North Quarry

NewTrashNorthQuarry2004.pdf

Image Date 02/29/2004 West Lake Landfill

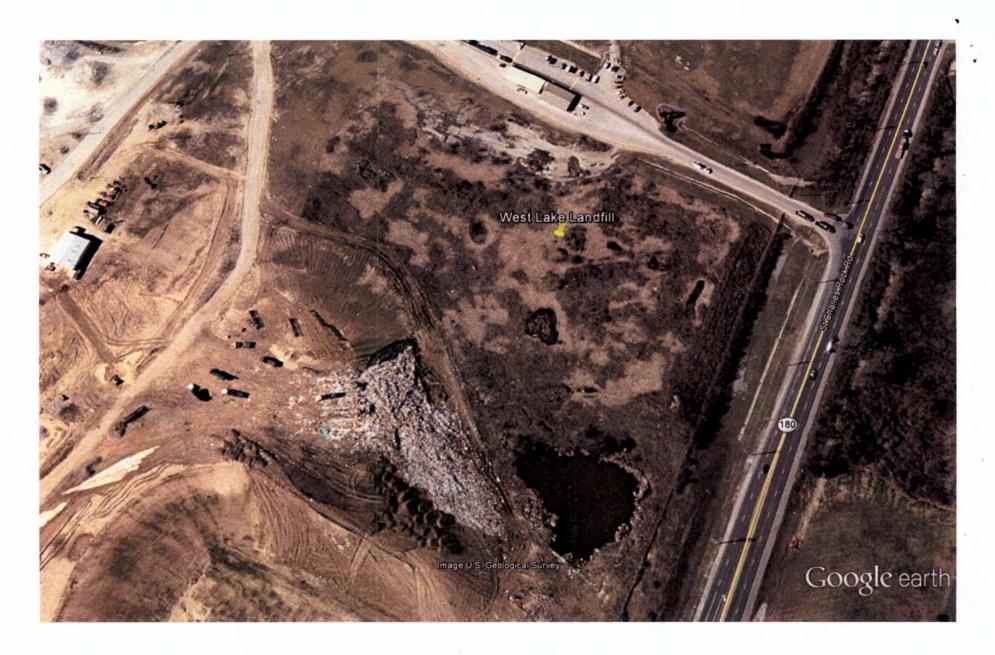
Attached is a photo from 2004 that shows the landfill owner at the time dumped new wastes along what appears to be near or part of the proposed isolation barrier. The refuse appears to only be 10 years old and within the range of decomposition that could lead to an independent SSE.
